Access Report

9 Gregory Hill Drive, Gledswood
Gledswood Hills High School

Prepared for: Department of Education (DoE)
Our Ref: 24000384 | Issue date: 19 December 2024

Figure 3. Access via Principal Pedestrian Entrance

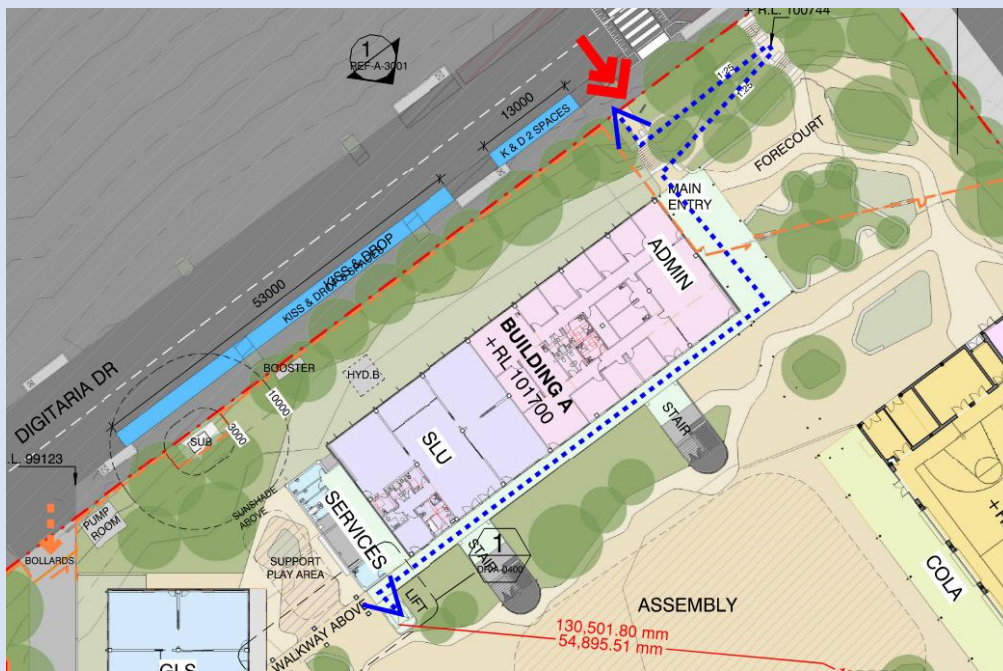
Compliance Comments
<p>Principal Pedestrian Entrance (PPE) linkage via Digitaria Drive:</p> <ul style="list-style-type: none"> ○ Access is achieved from the allotment boundary via compliant (1:25) walkway in accordance with AS1428.1 and DDA Premises Standards. ○ Stairs at allotment boundary provide set back of 900mm minimum as prescribed under AS1428.1. <p>It is noted that there is a distance of over 50m from the proposed lift to the furthest stairwell, raising an equity-of-travel-distance issue. The nominated location of the lift is based on the following rationale:</p> <ul style="list-style-type: none"> ○ The lift is positioned in the building closest (facing Digitaria Drive) to the Principal Pedestrian Entrance (PPE) for staff, students, and visitors. ○ It is located adjacent to the Support Learning Unit home base on the ground floor of Building A. ○ All buildings are linked via outdoor covered walkways that provide on-grade, weatherproof access to all levels and potential areas for respite along the paths of travel. ○ The stairs located more than 50m from the lift are in Building C, situated closest to the secondary entry of GHHS. ○ Accessible car parking bays have a direct line of sight to the lift's location.

Figure 5. Access from the Access car parking bays to Lift Access

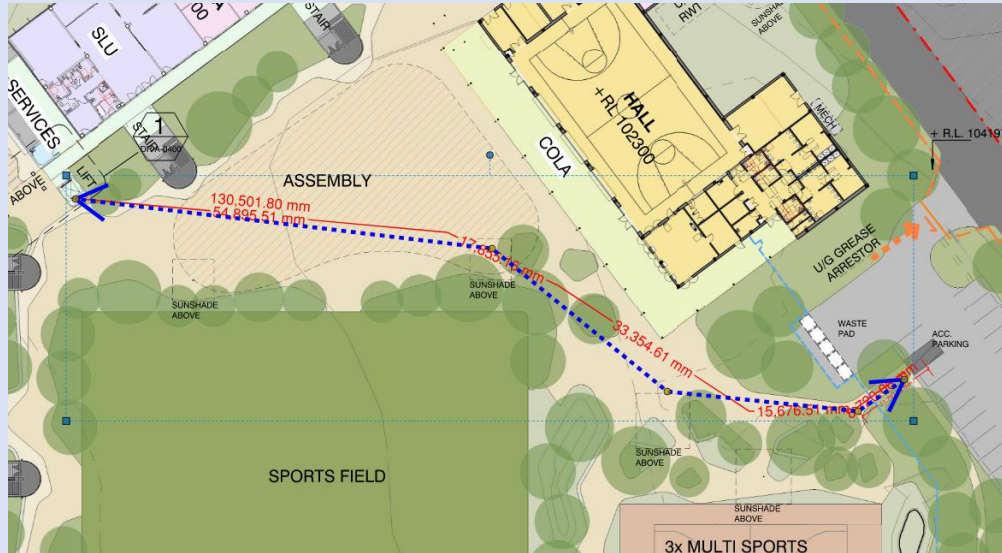
Linkage to Accessible Carparking Bay:

- Access is achieved from the accessible car parking bays (x2) to passenger lift via assembly area in accordance with AS1428.1 and DDA Premises Standards.
